## Sporting Bulletin n°2

**Subject:** Throttle potentiometer sealing

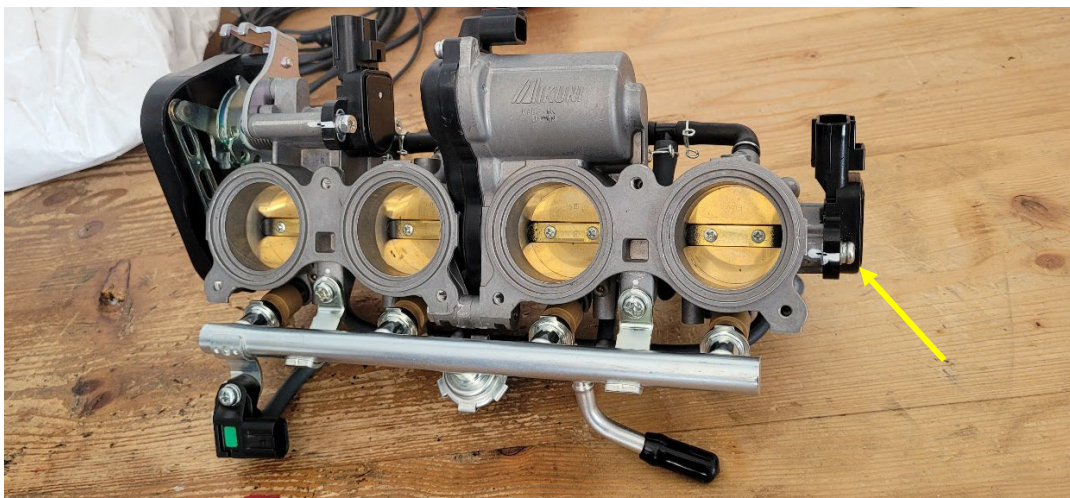
From round 3 of the FIA European Cross Car Championship, throttle potentiometer of the Yamaha R6 and MT09 engines will be sealed by the FIA technical delegate.

After the throttle learning control procedure and its validation by the FIA technical delegate, a seal for the throttle potentiometer fixing screw will be installed.

- Remove this screw,

- Replace it with this drilled screw provided by the FIA technical delegate :

- Installation of the FIA brake wire and seal by the FIA technical delegate
